STATE OF NORTH CAROLINA
DEPARTMENT OF TRANSPORTATION

SUBJECT: Request for Modification of Section 404 Individual Permit and Section 401 Individual Water Quality Certification for the new location facility Asheboro Southern Bypass and Zoo Connector, Asheboro, Randolph County; Division 8; TIP No. R-2536; Debit \$ 570.00 from WBS Element 34450.1.1

The project was authorized by the USACE and NCDWR as referenced above. The purpose of this letter is to inform you of changes in the project that required updated design plans and in some instances resulted in changes in impacts for Sections 1, 2, and 3 of R-2536.

US 64 Bypass, R-2536 Permit Modification (Revision Log)								
5/16/2017 								
	Permit Drawings Sheet #	Nearest Permit Site	Location	Change / Issue	Additional / Less Impact	Date of Change	Permit Drawing Re-Issued	Permit Revision Date
SECTION 1 JMM	2, 3, 4	N/A	N/A	Revised Begin and End stations and Added or Removed ditches from details to match plan and profile.	N/A	11/23/16	Yes	3/30/2017
	8, 9	2	-Y1A-	Roadway and Drainage revised for -Y1A-	N/A	1/11/17	Yes	3/30/2017
	12, 13, 14	3	-SR1-Sta. 19+00	Revised pipe from str. 745 to 744 from CSP to RCP	N/A	11/23/16	Yes	3/30/2017
	12,

DETAIL SHEET FOR SITE 3

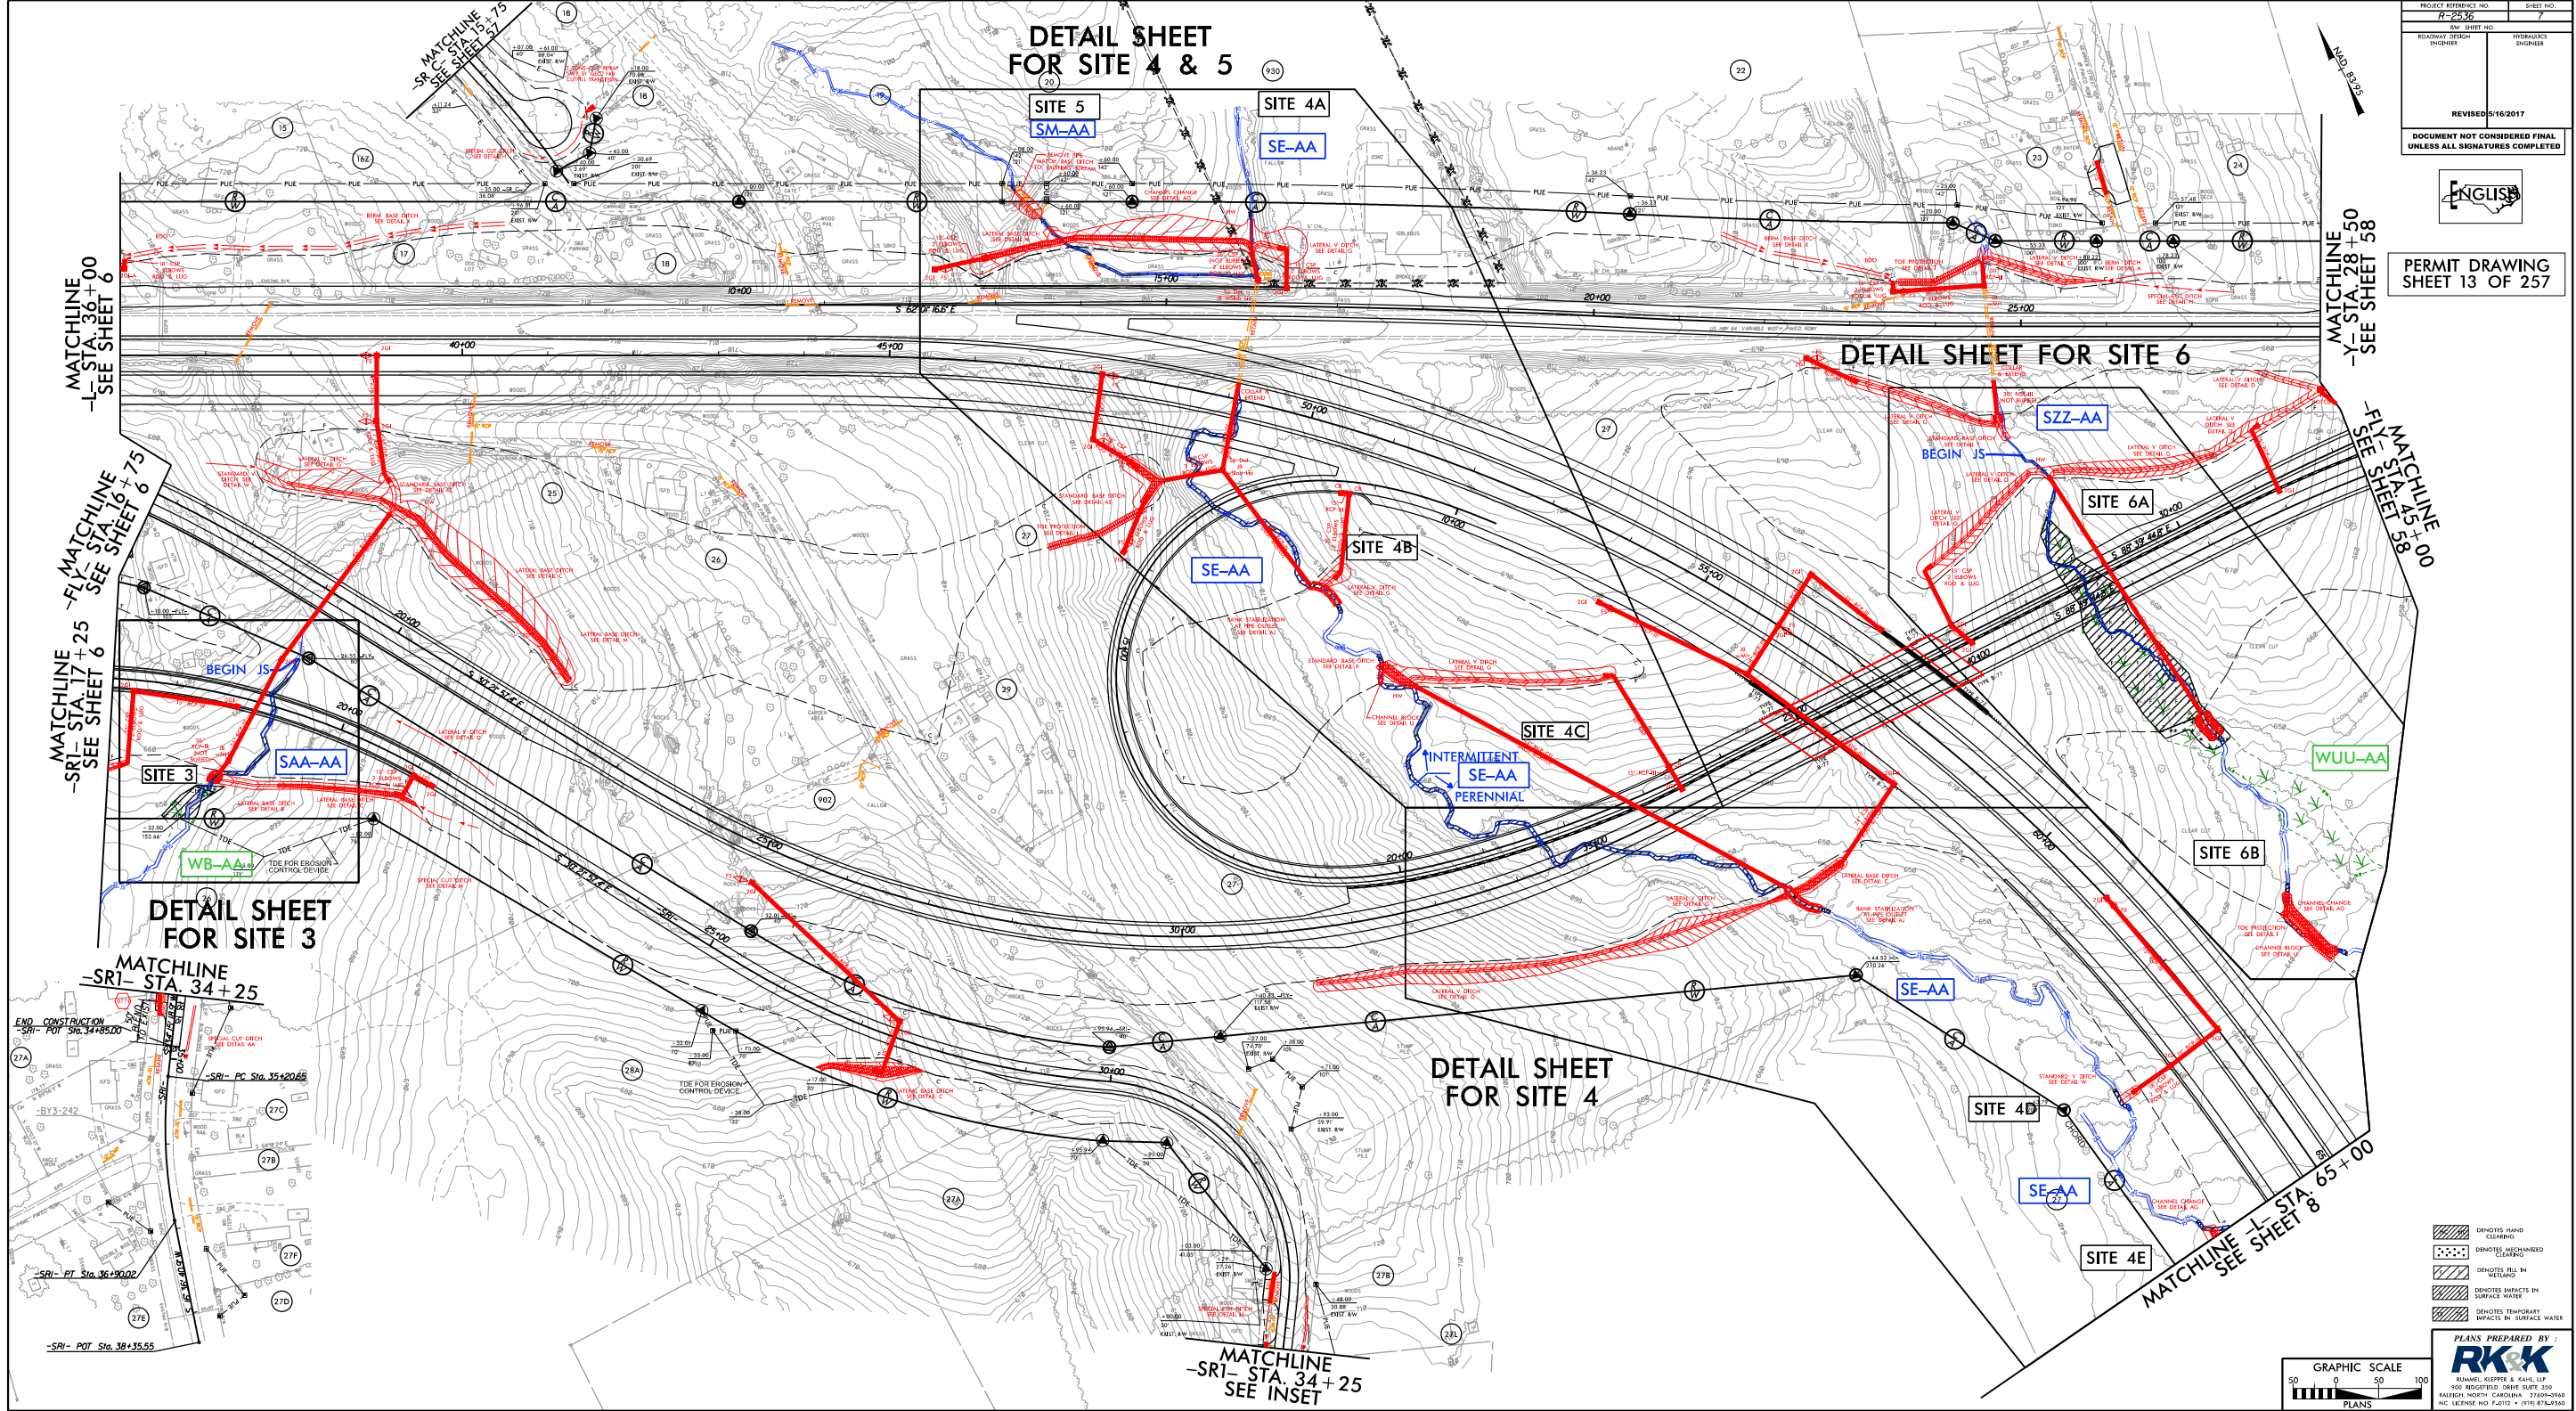
- Section 1: Site 3 – 0.03 acre of additional wetland vegetation hand clearing due to aerial utility impact (approved via email correspondence with NCDWR 11/7/2016 and USACE 11/9/2016).
- Section 1: Site 4B/4C - A reduction of 127 feet of permanent and increase in 20 feet of temporary stream (waters of US) disturbance/filling. Requested to leave existing vegetation along stream banks inside loop and not install rip rap along banks (approved verbally by NCDWR 10/18/2016 and via email correspondence with USACE 1/3/2017).

**SITE 86 And 87
PLAN VIEW**

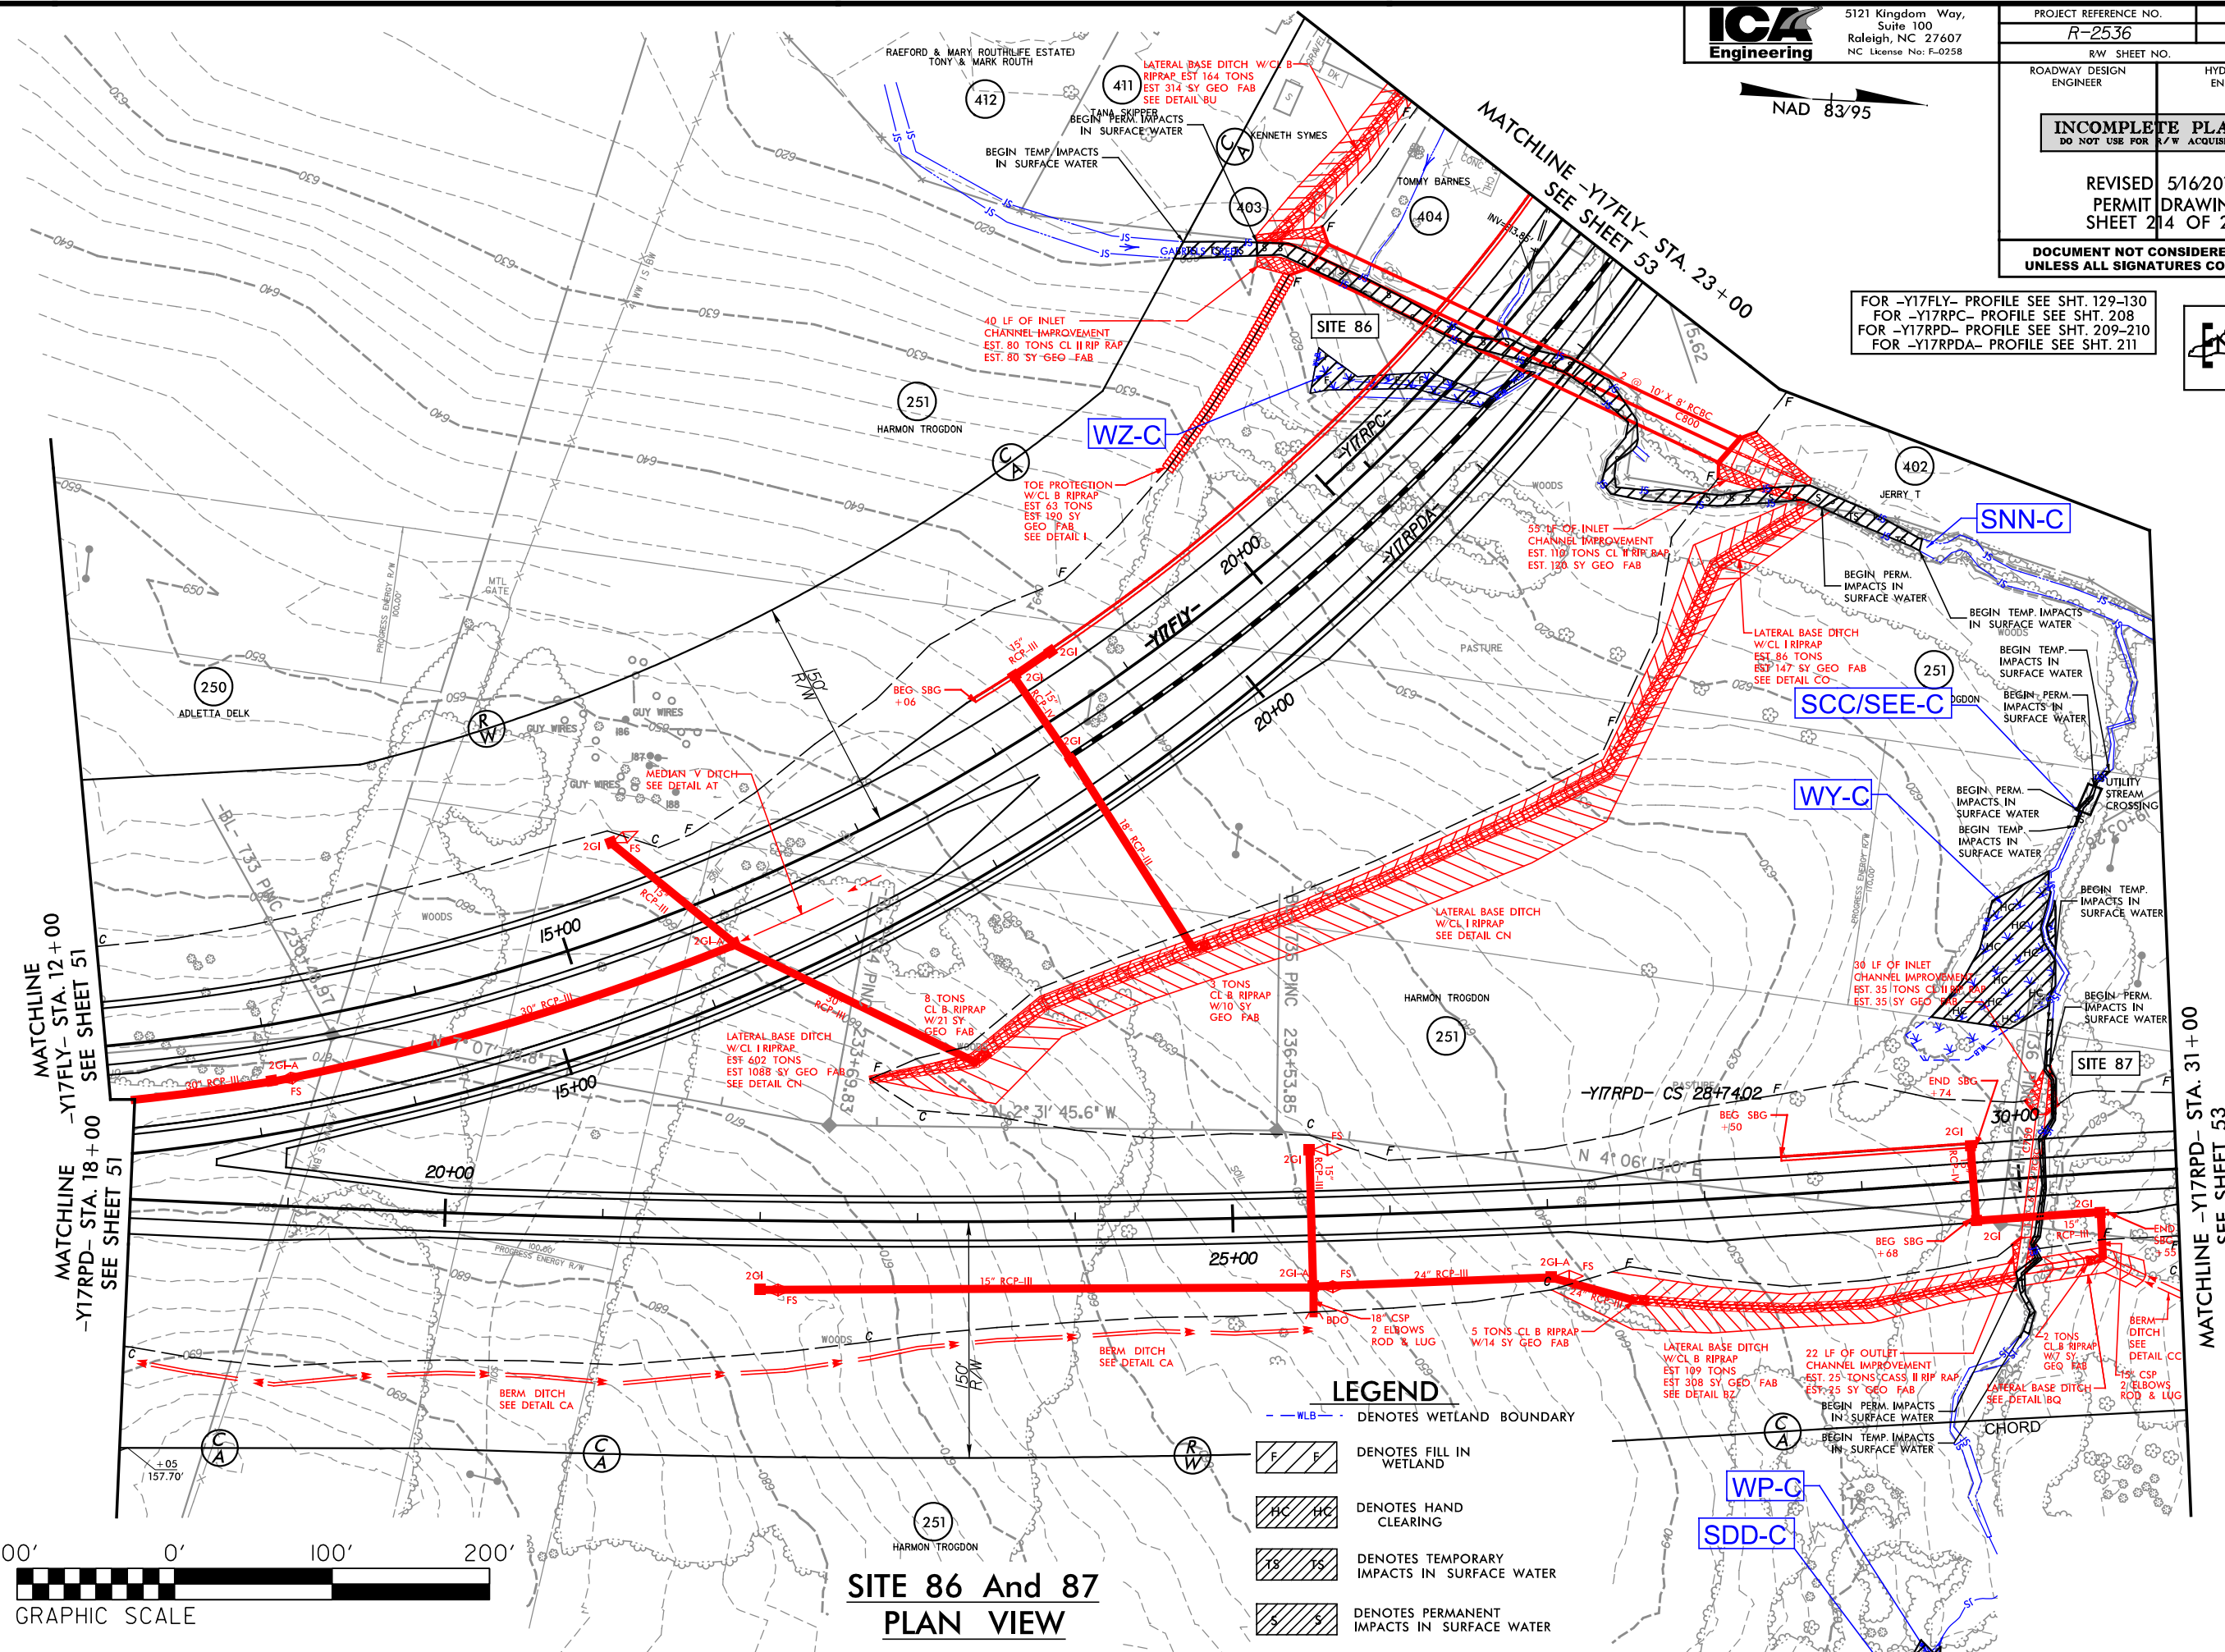
213, 214, 216	87	-Y17RPD- Sta. 30+00 LT	Revised utility transmission line location. The revised location impacts wetlands WY-C, west of site 87.	+0.1 ac Hand Clearing, +19' Perm. & +22' Temp. Stream	3/30/17	Yes	3/30/2017
	221, 222	95	-Y17- Sta.53+00-58+00	Roadway revision for lane continuity. Taper added along -Y17- and Drainage revised in loop.	N/A	3/30/17	Yes	3/30/2017
	239, 240, 242	100	-Y17- Sta.75+00-84+00	Roadway revision for lane continuity. Median Taper revised and concrete island added near -SRD6-	N/A	3/30/17	Yes	3/30/2017
SUMMARY	248			Summary Table		3/30/17	Yes	3/30/2017
	252			Summary Table		3/30/17	Yes	3/30/2017
	255			Summary Table		3/30/17	Yes	3/30/2017
	257			Summary Table		3/30/17	Yes	3/30/2017
